Subject: Docket No. 50-206  
Seismic Safety Margins  
San Onofre Nuclear Generating Station  
Unit 1

SAN ONOFRE  
NUCLEAR GENERATING STATION  
UNIT 1

SEISMIC SAFETY MARGINS WITH RESPECT TO THE  
84TH PERCENTILE INSTRUMENTAL SPECTRUM

### 3.0 RESPONSES TO NRC REQUEST FOR ADDITIONAL INFORMATION

FIGURE 1

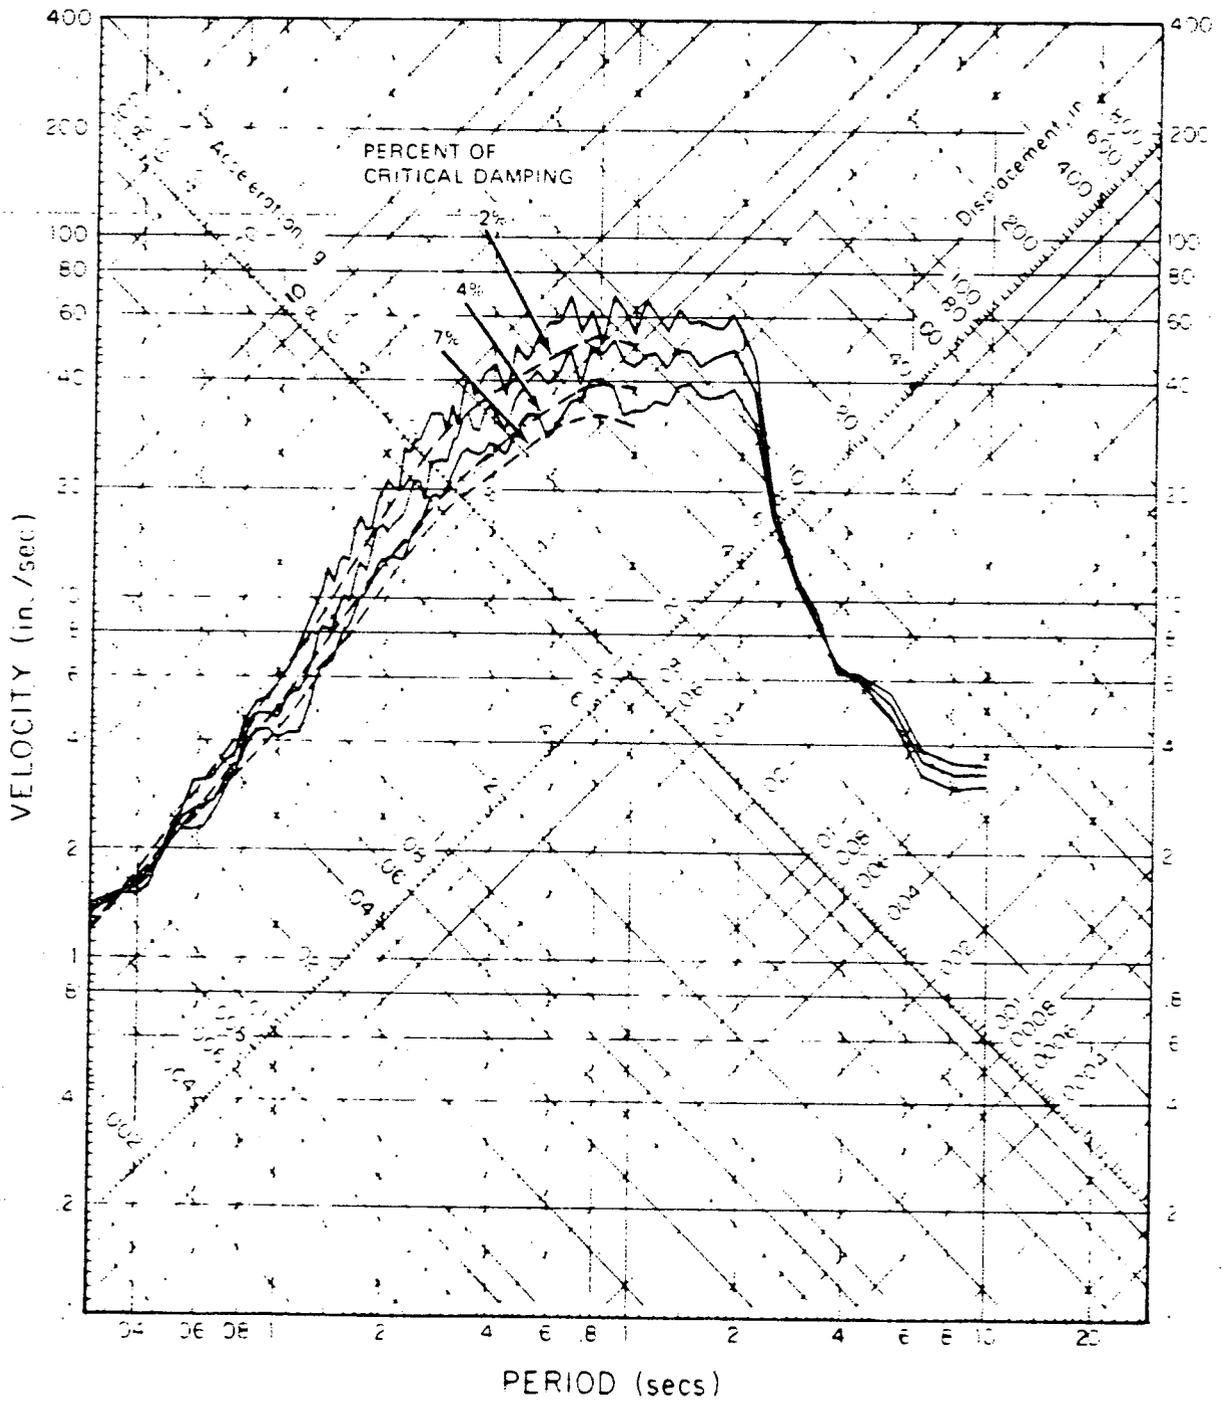
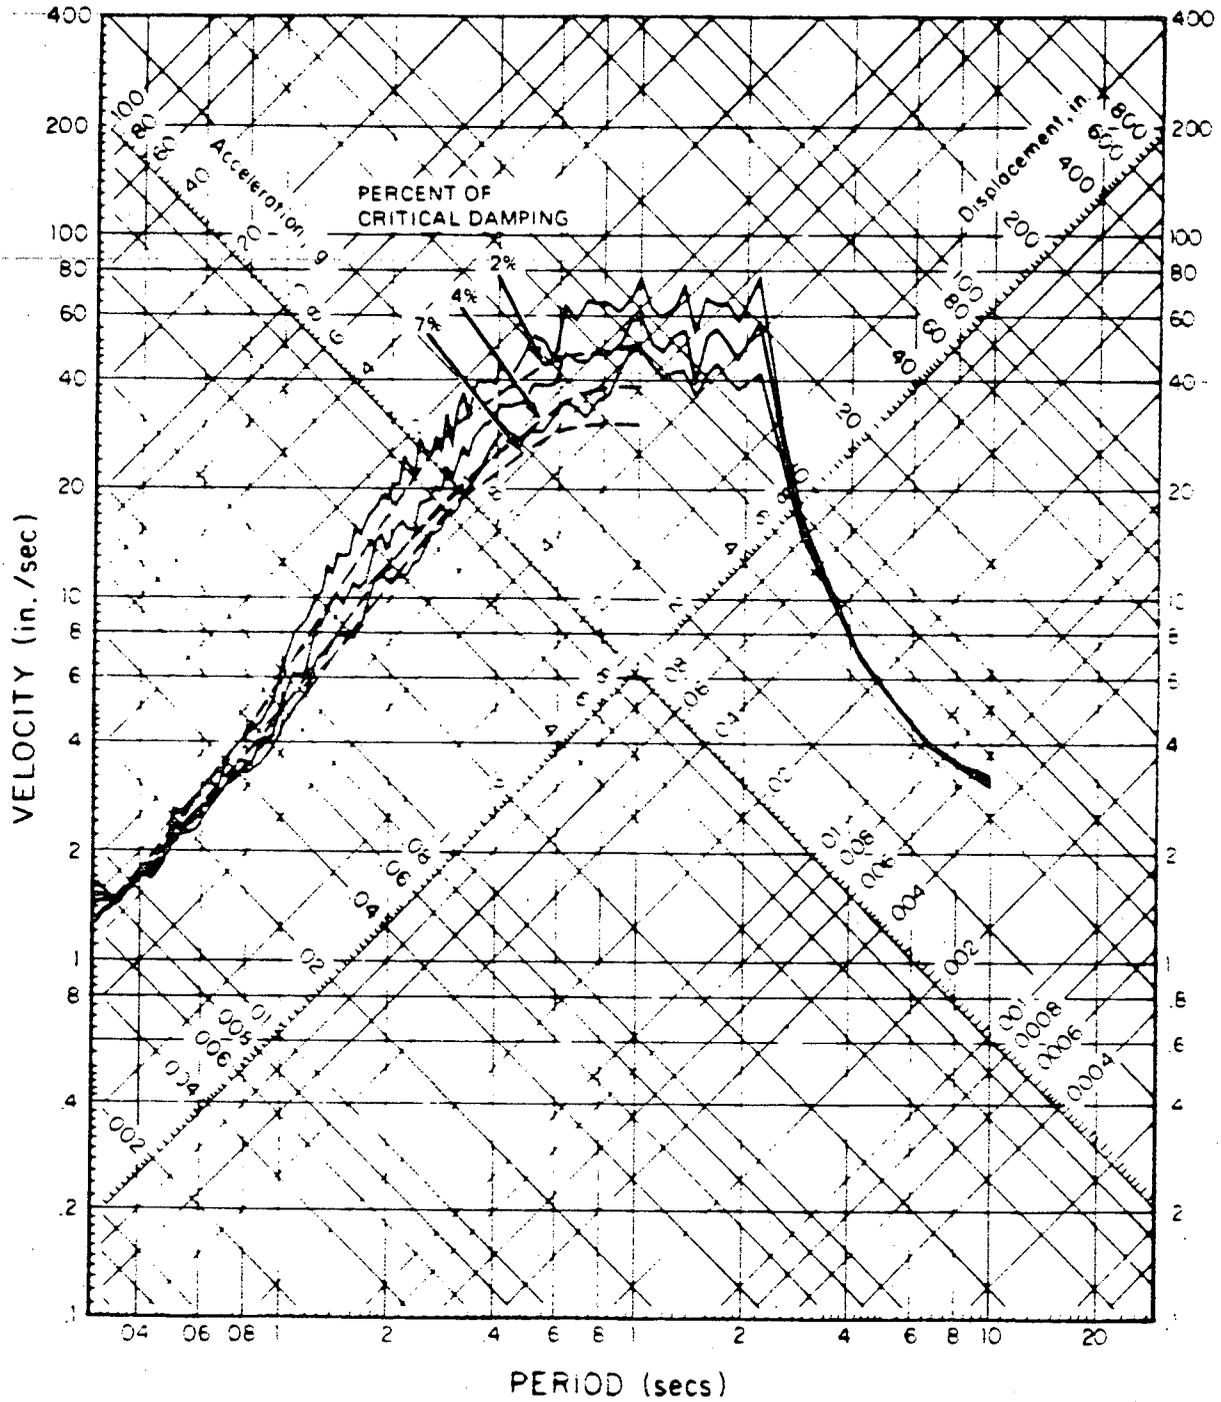
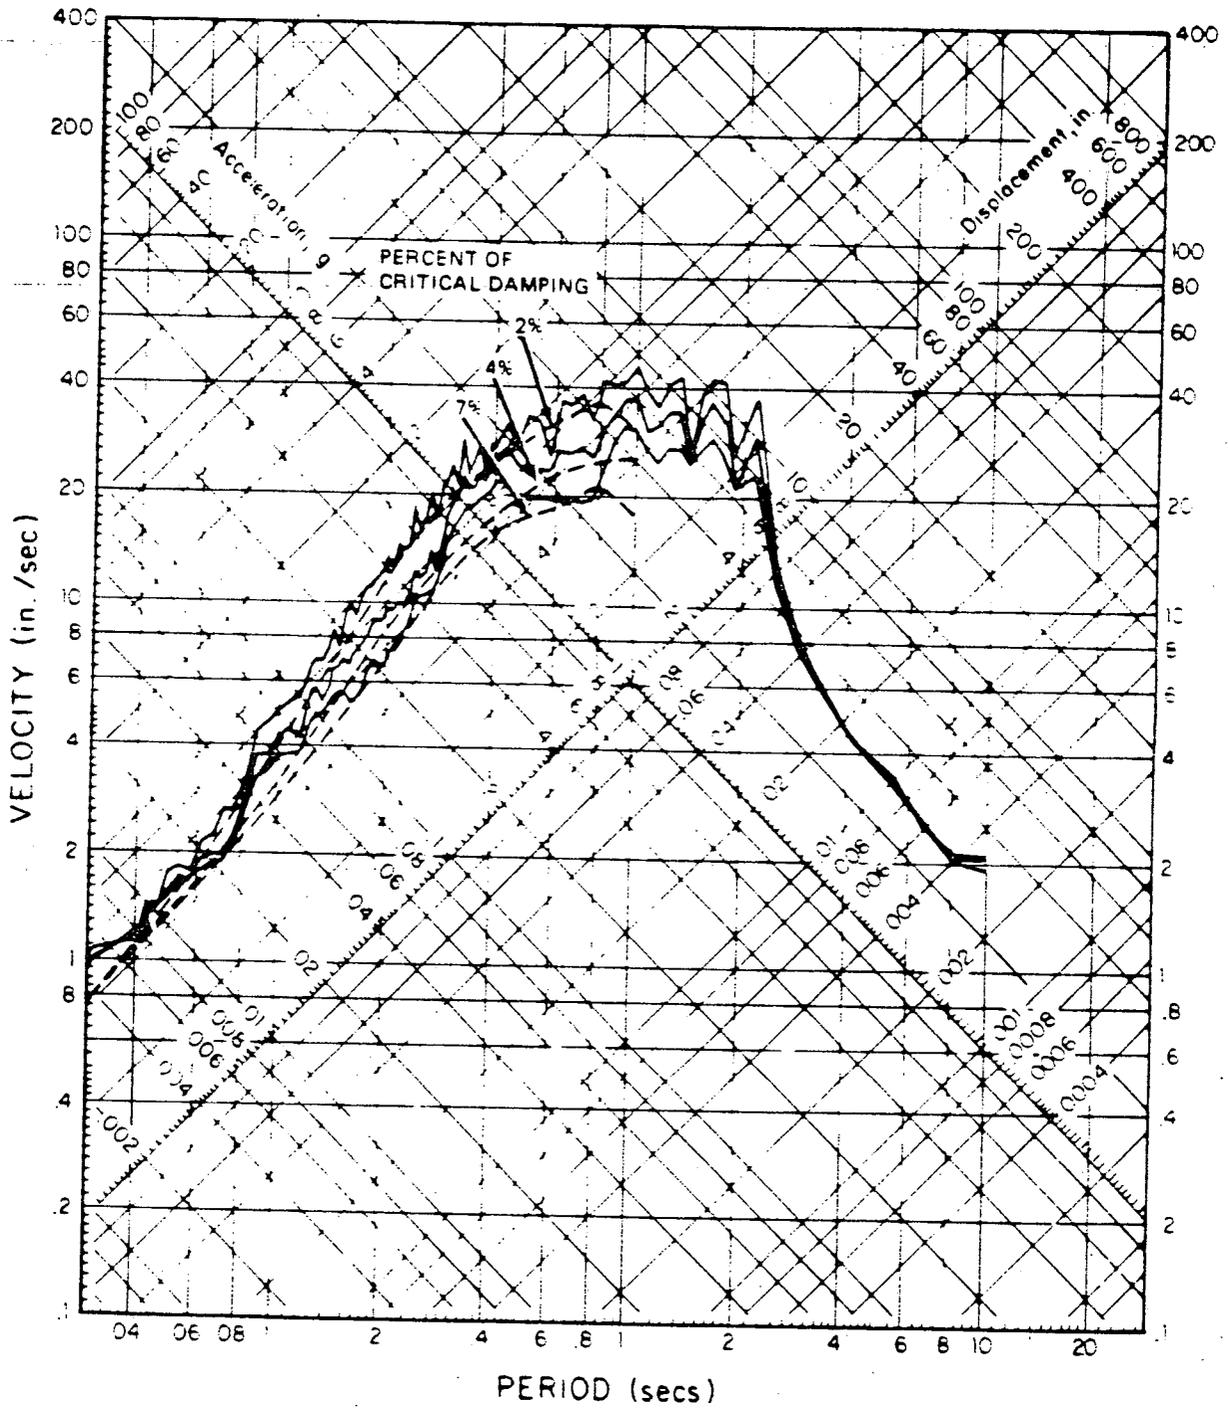
Describe for each of the structures, systems (e.g., reactor coolant loop), and components, the effects of this increase in response spectra on the calculated loadings (moments, shears, and bucklings, etc.), stresses and displacements when either a nonlinear analysis or an inelastic response spectrum analysis (using ductility concept) was used to account for inelastic behavior and justify their adequacy.

Nonlinear analysis methods were used for the evaluation of the reactor coolant loop. The comparisons of the Housner ground spectra and the spectra of the two horizontal and the vertical design time histories used in the evaluation of the reactor coolant loop are shown in Figures 1 through 3 for 2, 4 and 7 percent critical damping values.

Table 3 shows the average difference of the spectra of the design time histories and the horizontal Housner spectra in the period range from 0.07 second to 0.25 second and the vertical Housner spectra in the period range from 0.05 second to 0.15 second. The average differences over the specified period ranges were calculated considering the values at 20 specific periods for the horizontal spectra comparisons and at 18 specific periods for the vertical spectra comparisons. It is concluded that the spectra of the design time histories satisfactorily envelop the 10% exceedances of the Housner spectra over the specified period ranges. Thus the nonlinear evaluation of the reactor coolant loop will not be affected.

FIGURE 4 | COMPARISON OF SCALED EARTHQUAKES WITH HOUSNER

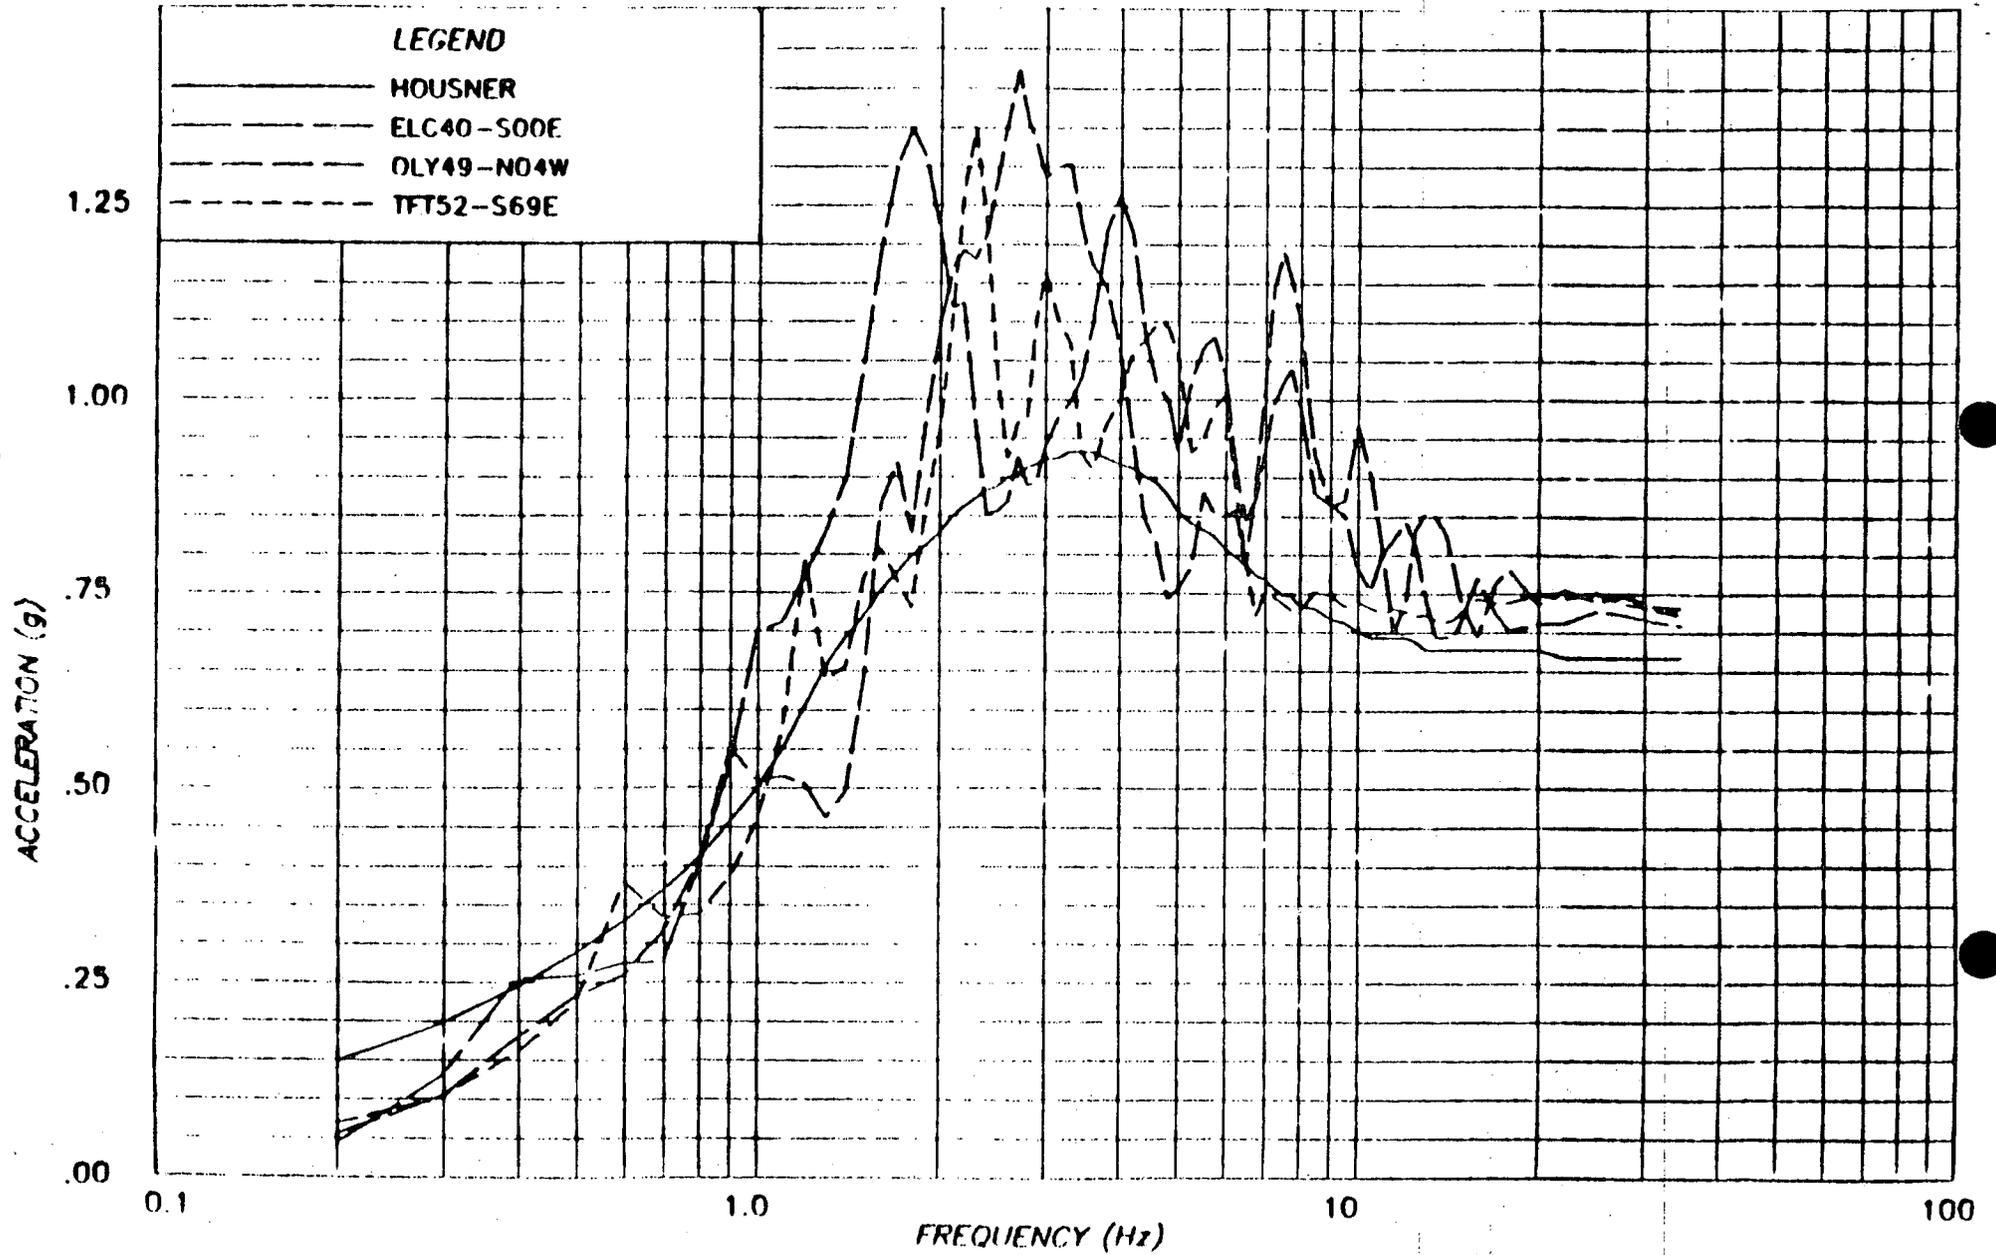
Describe the effects of this increase in response spectra on the calculated loadings (moments, shears, and buckling, etc.), stresses and displacements of masonry walls where nonlinear inelastic analyses were used. Justify that the integrity of these walls would not be compromised and equipment supported by or penetrating through these walls would not be adversely affected by the increase in response spectra.

In Figure 4 the 7 percent damped Housner spectrum is plotted together with the three earthquake components listed above. It can be seen that the three components collectively envelop the Housner spectrum throughout the frequency range of interest. It should also be noted that the El Centro May 18, 1940 S00E time history by itself almost completely envelops the Housner 7 percent damped response spectrum and that the envelop of the three time-histories exceeds the Housner response spectrum by a substantial margin in the amplified region of the spectrum (at some periods by nearly 100%).

FIGURE 10  
 DESIGN TIME HISTORY RESPONSE  
 SPECTRUM

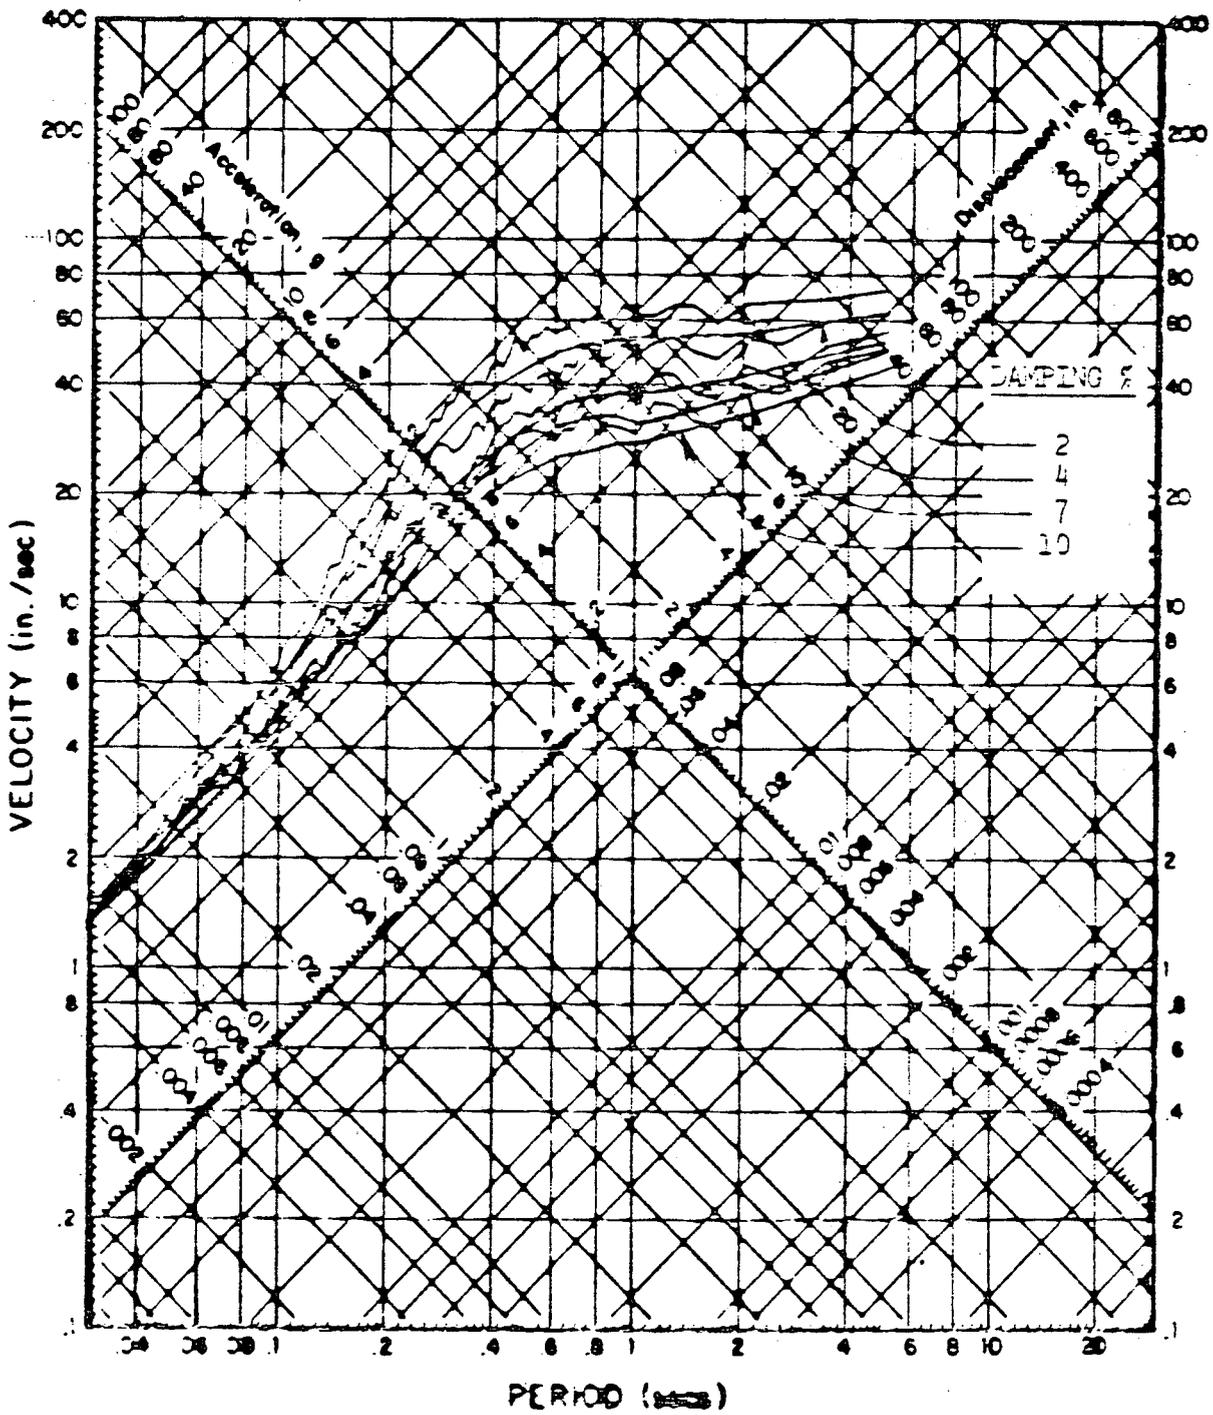
Describe the effects of this increase in free field response spectra on the floor response spectra that were used for the qualifications and/or analysis of walls, piping, mechanical and electrical equipment and justify that the walls, piping, mechanical and electrical equipment are adequately designed.

The comparison of the horizontal Housner design spectra and the spectra of the design time history used in developing instructure response spectra is shown in Figure 10 for 2, 4, 7 and 10 percent critical damping values. The comparison of the vertical design time history is identical since it is taken as 2/3 of the horizontal design time history.

As may be seen, the spectra of the design time history conservatively envelop the Housner spectra. The margins decrease for higher damping values, especially in the vertical direction. However, the overall effects of exceedances of the Housner spectrum by up to 10% are not considered to be significant because the spectra of the design time history are within a few percent of these exceedances and because of the conservatism discussed below for the evaluation of systems and components.
